At the beginning, we would like to thank Referee #1 for useful comments which helped us improve the manuscript. Our response is given bellow.
For easier referring to the each comment we also include the full Referee #1 review in black, together with our answers in blue.

RC1: ['Comment on gmd-2021-118'](#), Anonymous Referee #1, 08 Sep 2021 [reply](#)
General comments

Figure 1: Comparison of performance measures for SIMO, GOTM and SCHISM for the period from 01.01.-27.12.2019.

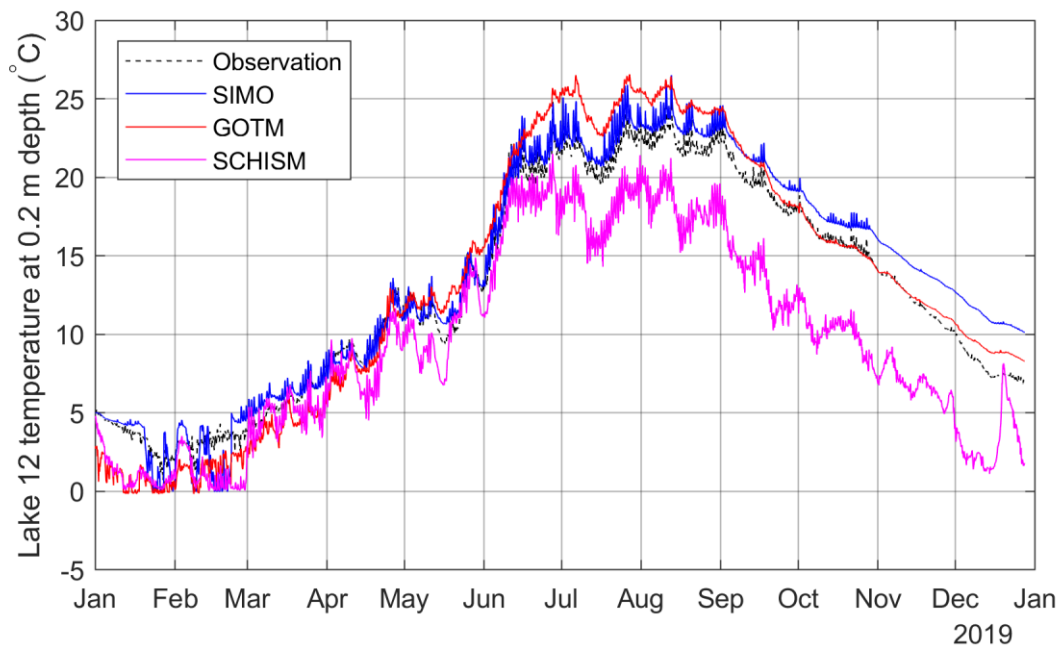
The first topic deals with estimating the heat fluxes at the lake surface in the absence of direct measurements of shortwave and longwave radiation. Such parameterizations of the surface heat fluxes have been previously described in numerous publications. If there is any novelty in the approach that the authors use here for this purpose, it is not made clear to the reader. The only thing that I haven't seen in the context of lake modelling is the suggestion to derive the daily dynamics of solar radiation from UV-B measurements. However, this seems to be mainly a workaround for this specific case than a generally applicable approach, as in general, observations of global radiation are much more frequently available than observations of UV-B radiation. Furthermore, the approach used in the study does not allow to check whether the applied heat flux parameterization works well. In fact, the results seem to indicate that it doesn't, given that simulated lake surface temperatures significantly and consistently overestimate observations even in very short model runs of a few days.

Nevertheless, to better assess proposed model performance, in the revised manuscript we added a new section "6 Comparison with other models", where we compare SIMO model results with the results of two other, more complex models (GOTM and SCHISM). It is shown that departures of modeled values from observations at the lake surface are comparable for all three models and that SIMO even outperforms the other models in some periods, especially SCHISM. The results are also shown in the table and figure below.

Figure 2 Modeled mean diurnal variations in the heat flux at the surface of Lake 12 for January (a) and July 2019 (b).

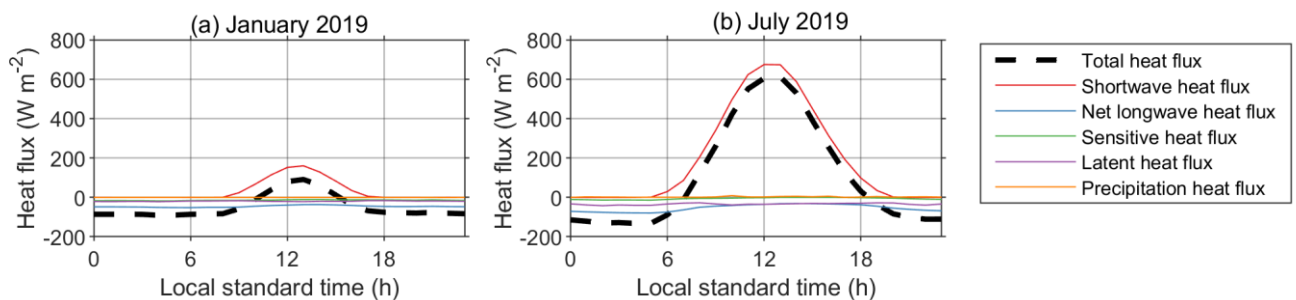
[16] Figure 5: There is something wrong here. The theoretical upper limit of the shortwave heat flux is the solar constant of 1368 W/m², the typical upper limit of observed surface solar radiation is about 1000 W/m². The July peak in the figure is 20'000 W/m².

Thank you for noticing. A mistake was made only in the part of the code responsible for plotting the heat fluxes (instead of the mean, the monthly sum was shown). However, this was done for all the components which means that the graph was at least qualitatively correct, as well as the conclusions drawn from it. The graph has now been corrected.

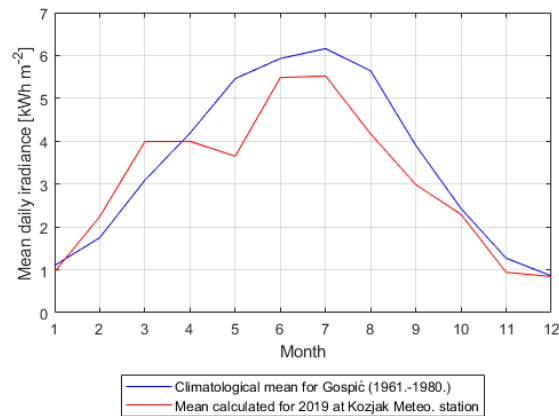
[17] Line 396: Add some quantitative information about the error in the onset of stratification. That is difficult to read from the figures.

For Lake 1, the position of the maximum temperature gradient in the metalimnion, between 12 and 16 m depth was captured even in the 30-day simulations (Fig. AError! Reference source not found.), but the temperatures in the epilimnion are significantly overestimated in the stratification period (August) in the longer runs (Figs. Error! Reference source not found. and AError! Reference source not found.).

For Lake 12, the difference between the predicted and observed position of the maximum temperature gradient is within 2 m even for the 30-day simulations, but generally it is lower. Temperature overprediction is noticed in the epilimnion, especially towards the end of the year for the simulation lengths above 10 days. The stratification began on 21 March and in the 30-day simulations it was predicted on 23 March, while the convective overturn began on 06 September while in the 30-day simulation it was predicted on 10 September.

Figure 3 Model performance parameters for Lake 1. (calculated for all the periods with necessary data available: 6.7.-31.12.2019. and 2.7.-30.9.2020.)

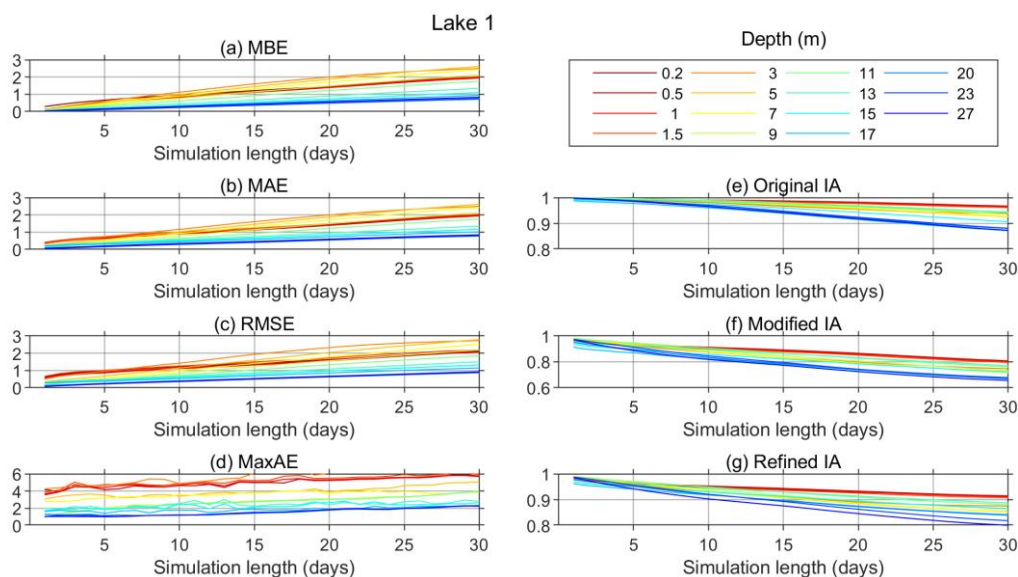
[18] Figures 9 and 10: for which period are these measures averaged? This should be mentioned in the caption of the figures. Also, the fact that the temperature bias at the lake surface is consistently positive even in simulations of very short duration (1 day),

seems to clearly indicate that there is something wrong with the surface heat flux parameterization (see main comment above).

Averaging periods have been added in the captions:

We agree and we do mention the surface heat flux may be one of the factors leading to the temperature bias at the lake surface. Since the major component of the net surface heat flux is the solar shortwave radiation, we did a rough check by comparing our estimations to a climatological mean for Gospić meteorological station which is the closest station for which climatological radiation data is available. Meteorological station Gospić (564 mASL) is around 40 km away from meteorological station Plitvička Jezera (579 mASL) and the region is characterized by complex orography leading to different microclimates. Furthermore we are comparing one year data to climatological data. Considering all that, no perfect match is expected. The comparison is shown in the figure below. It seems that the solar radiation was well estimated, and if anything it may be somewhat underpredicted (which is not necessary true, due to the different microclimate of the two places).

In the light of the model update regarding the light extinction model, it is our opinion that the main error was introduced through this part of the code which is now improved.
